SUBJECT: Forwards response to 900316 request for addl info re  
 emergency power sys enhancement project.

Re: Turkey Point Units 3 and 4  
Docket Nos. 50-250 and 50-251  
Request for Additional Information on  
Emergency Power System Enhancement Project  
NRC TAC Nos. 69023 and 69024

ATTACHMENT

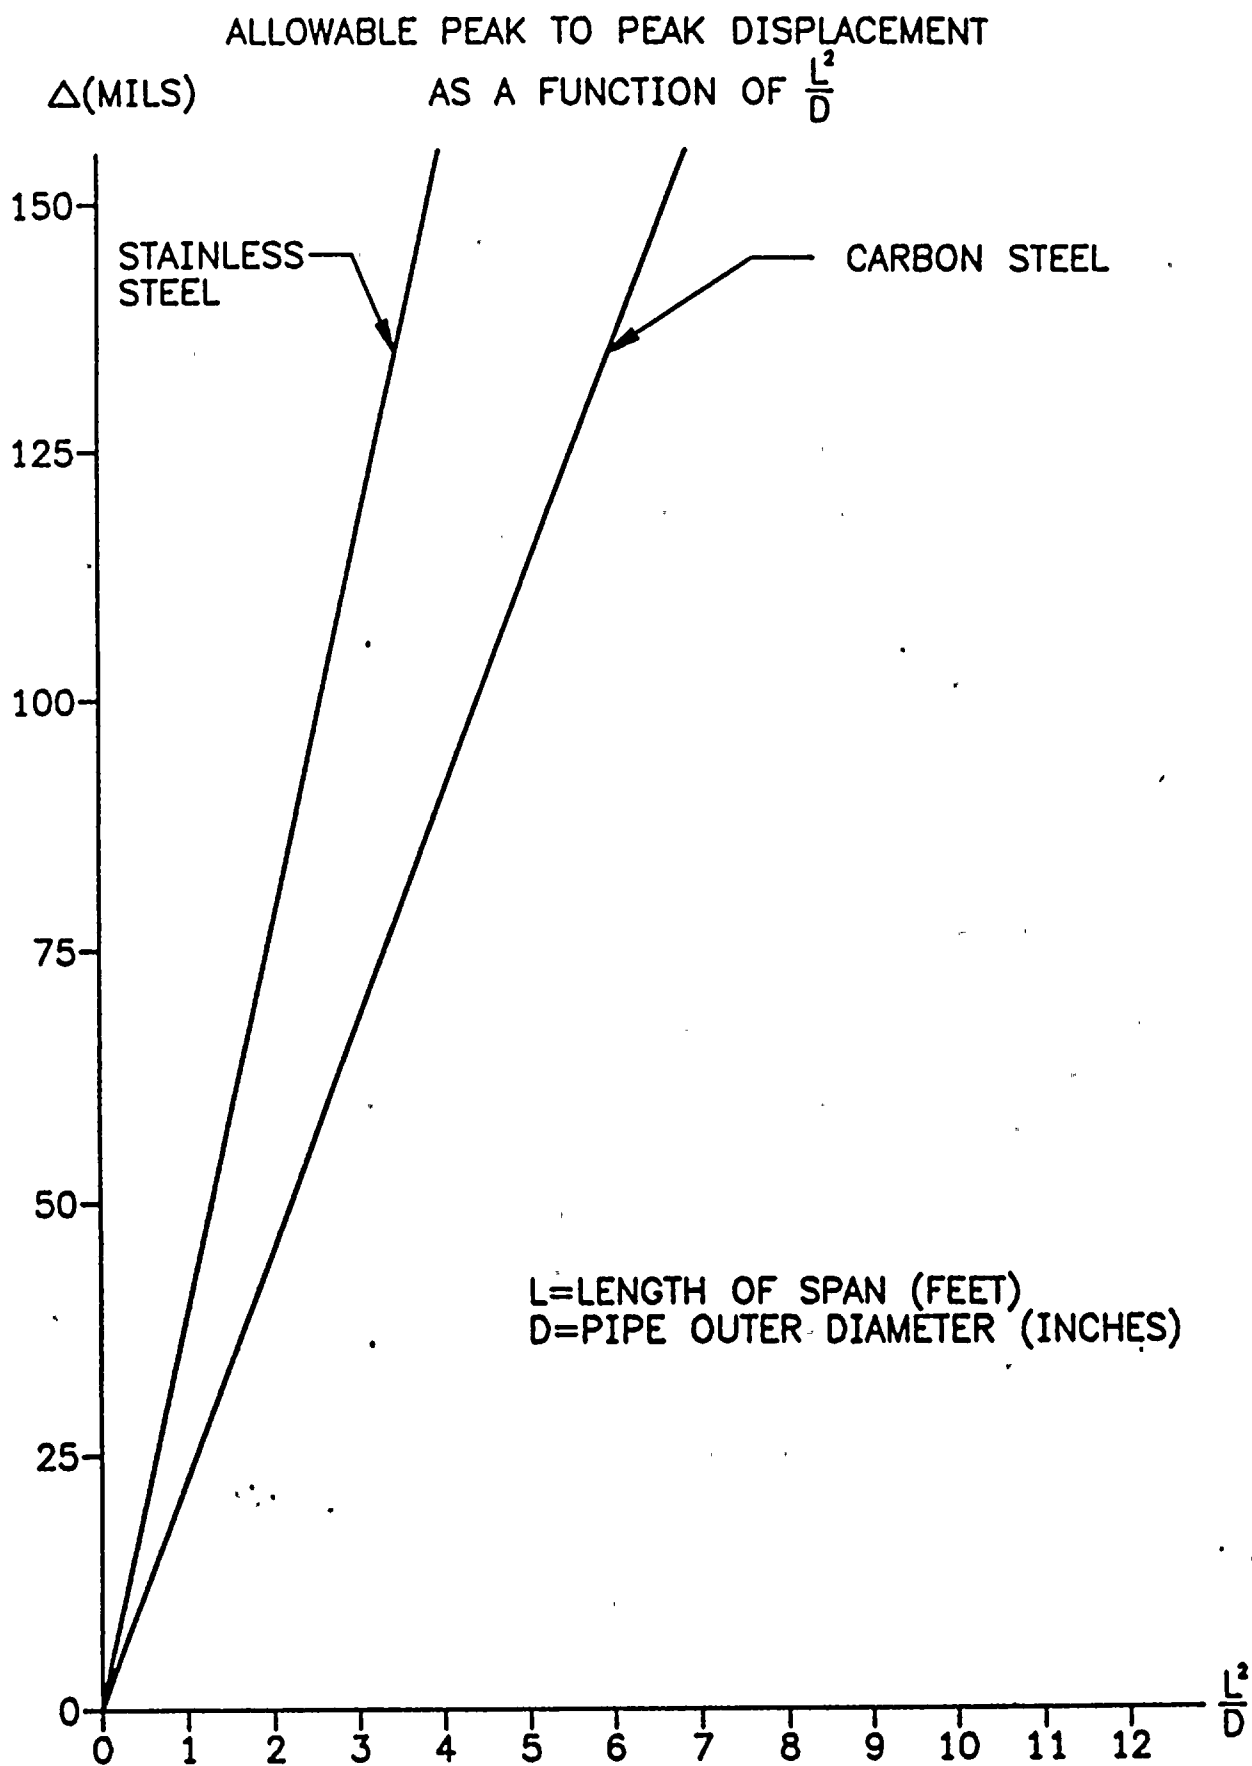
Please specify the criteria for acceptability of the piping vibration (during testing) for piping attached to the diesel generators.

All off skid piping systems connected to the diesel generators utilize flexible connections in order to isolate the piping from vibration generated by the diesel. The next page provides the acceptance criteria developed by the AE for piping vibration to be measured during start-up testing. Testing at the manufacturer's facility indicated that all skid mounted piping also met this criteria. Additionally, all instrument tubing was replaced with 3/8" diameter 0.065" wall 316 stainless steel tubing with 60" support spacing in response to IE Notice 89-07.

FIGURE 1-1  
EPS ENHANCEMENT PROJECT  
CIVIL/STRUCTURAL CRITERIA  
(NOT TO SCALE)

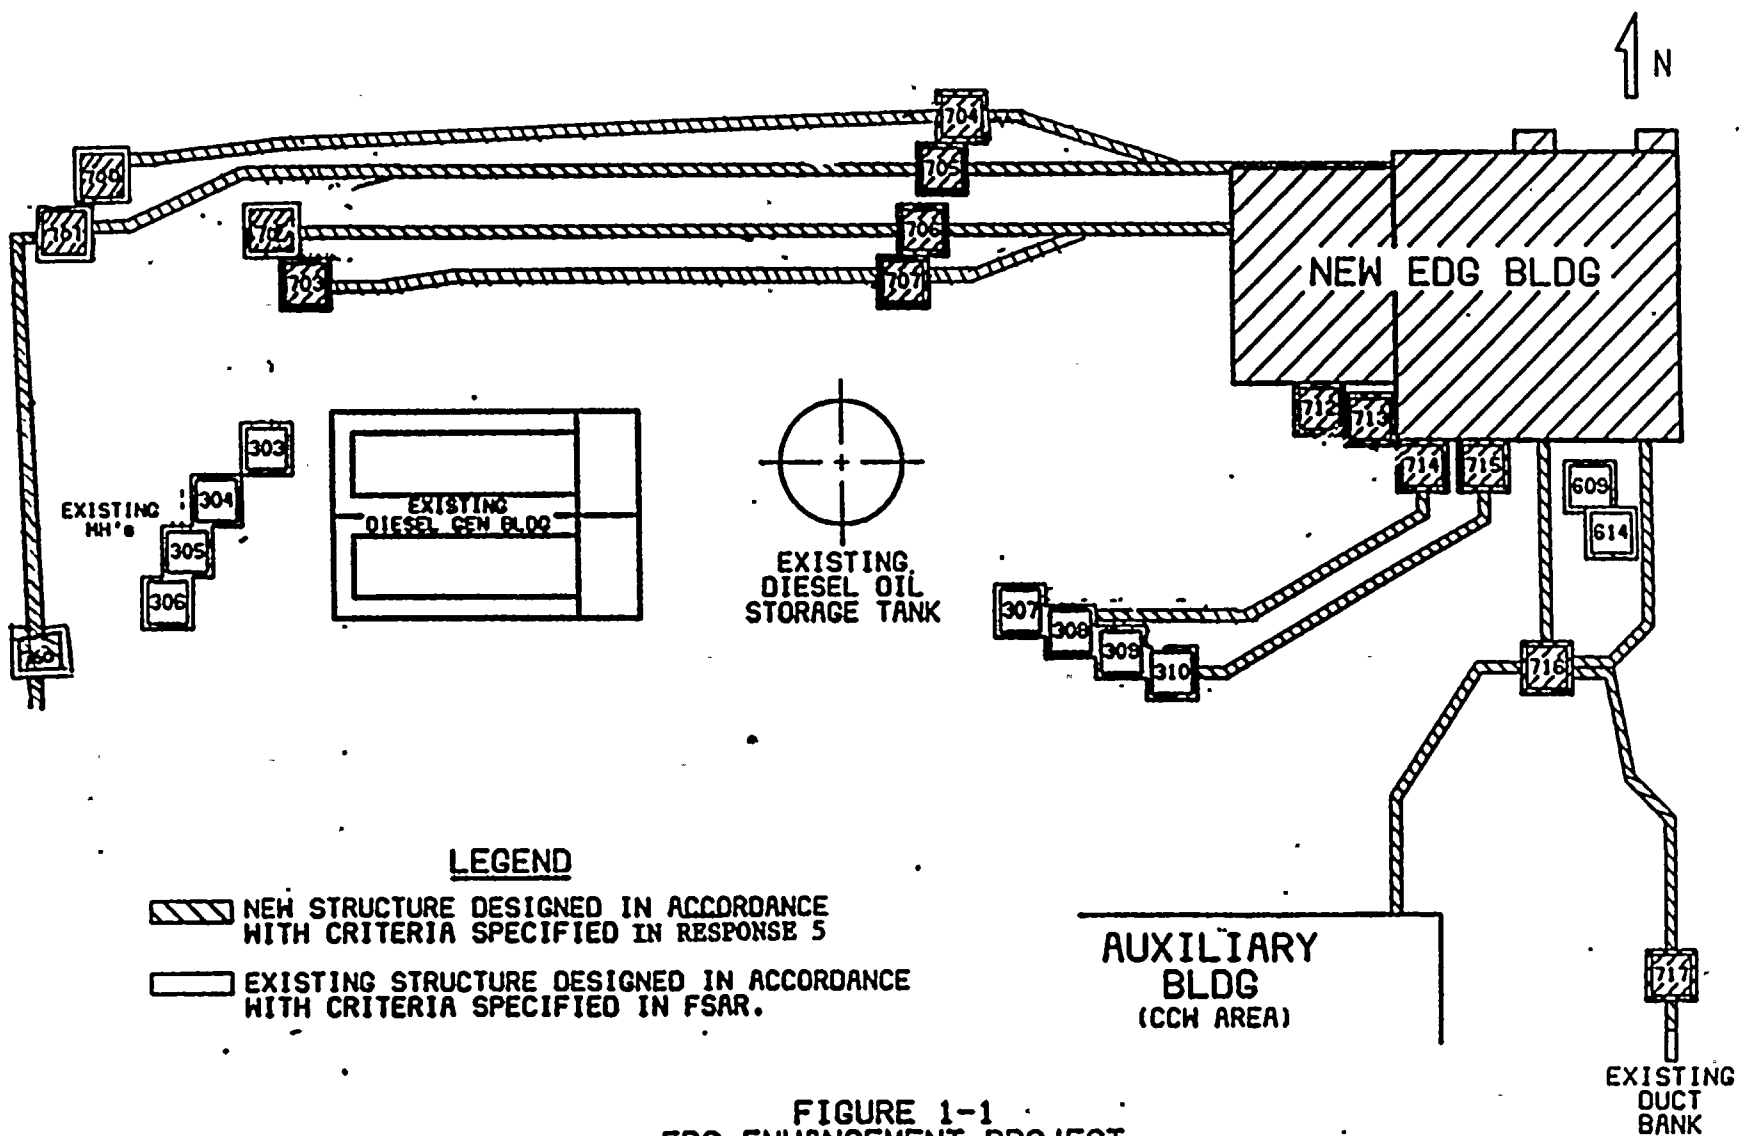
Please address how structural load combinations were considered.

The new EDG Building, all internal structures and all new exterior structures (i.e., ductbanks and manholes) as shown on Figure 1-1 (page 12 of 13) were designed in accordance with the following criteria. Modifications and additions to existing structures have been designed in accordance with the criteria specified in the Turkey Point Updated Final Safety Analysis Report (UFSAR).

The load combinations and structural acceptance criteria used in the design are in accordance with NUREG 0800 (Standard Review Plan - SRP) Section 3.8.4 as follows:
